Applicant: Chung Nam WHANG et al. Conf.: 7521
Appl. No.: 09/828,819 Group: 1773
Filed: April 10, 2001 Examiner: N.J. UHLIR
For: A MAGNETIC FILM HAVING EASY-AXIS OR A
MULTIPLE EASY-AXIS AND A METHOD OF
MANUFACTURING THE MAGNETIC FILM

PETITION FOR REVIVAL OF AN APPLICATION FOR PATENT
ABANDONED UNINTENTIONALLY UNDER 37 C.F.R. § 1.137(b)

REPLY UNDER 37 C.F.R. § 1.111

Fig. 2
Conventional Art

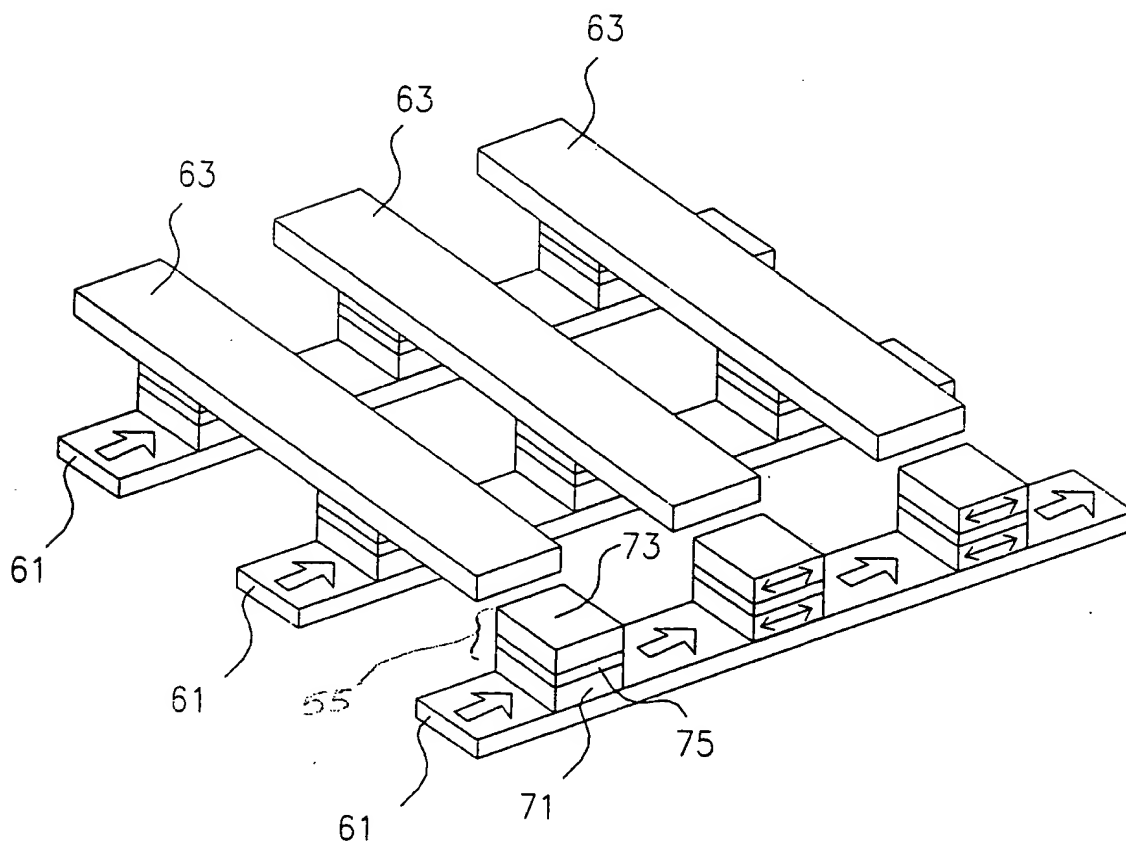
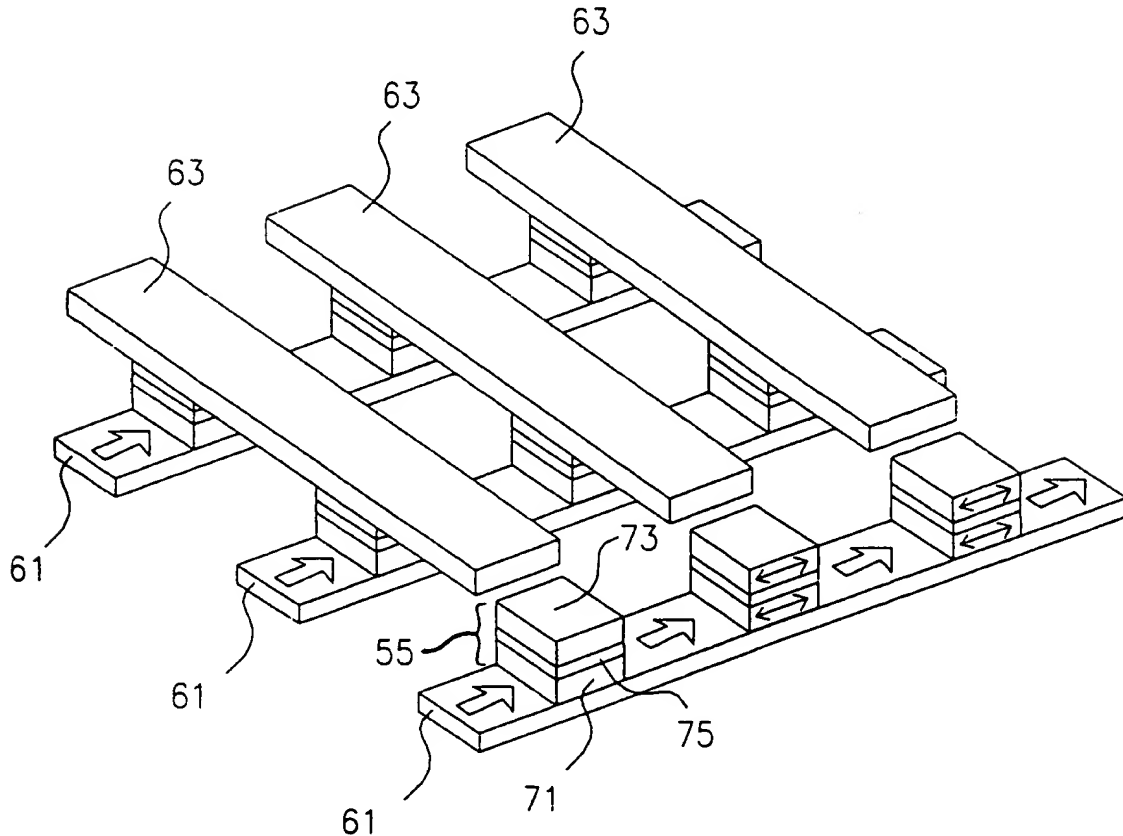
In Figure 2, add reference numeral 55 and its lead line; and

The Examiner objected to the drawings as failing to show reference numeral 55. Applicants have now amended Figure 2 to add this reference numeral and the appropriate lead line.

Fig. 6

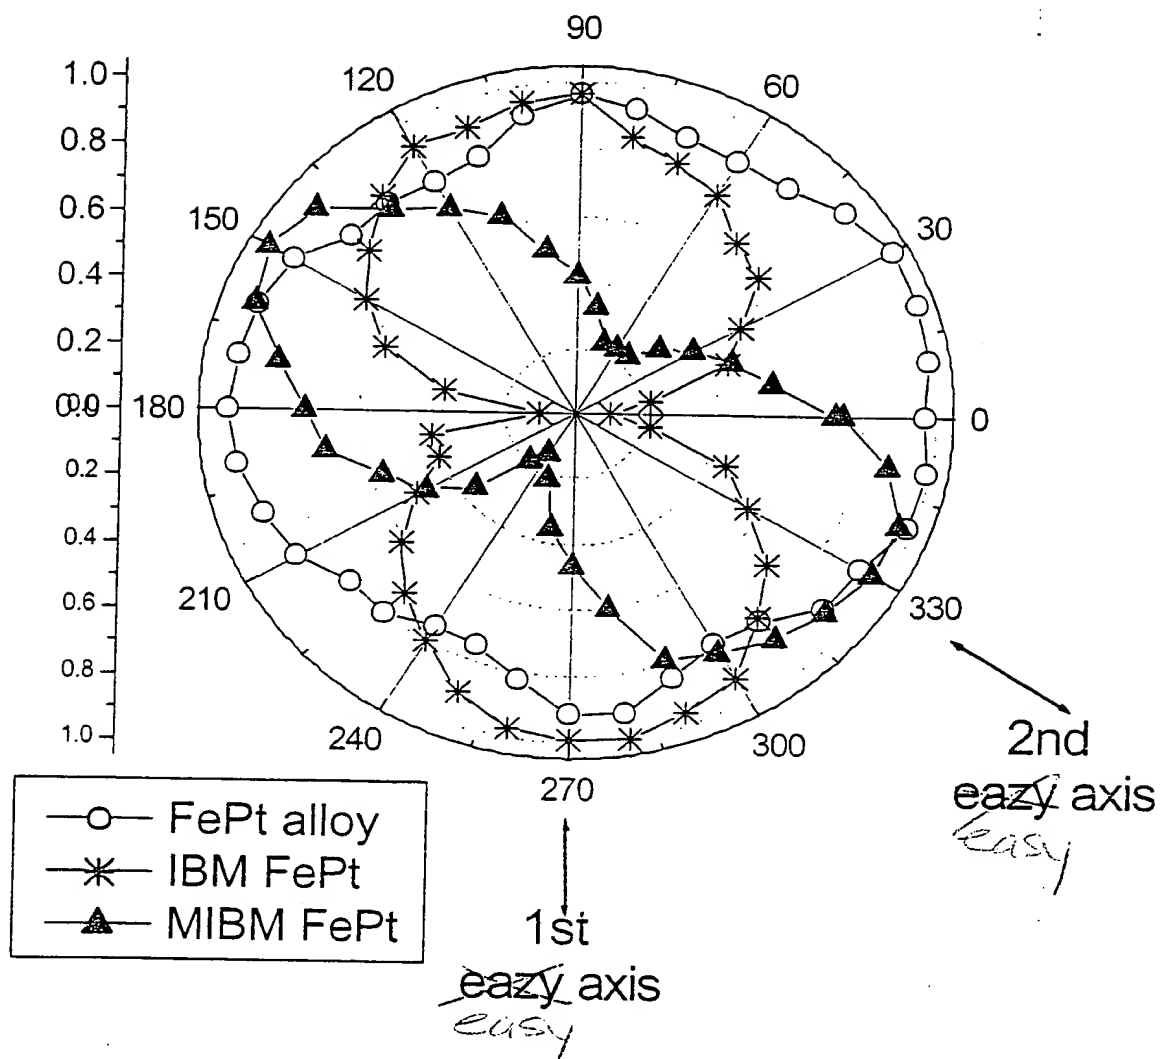
In Figure 6, correct the spelling of the word "easy."
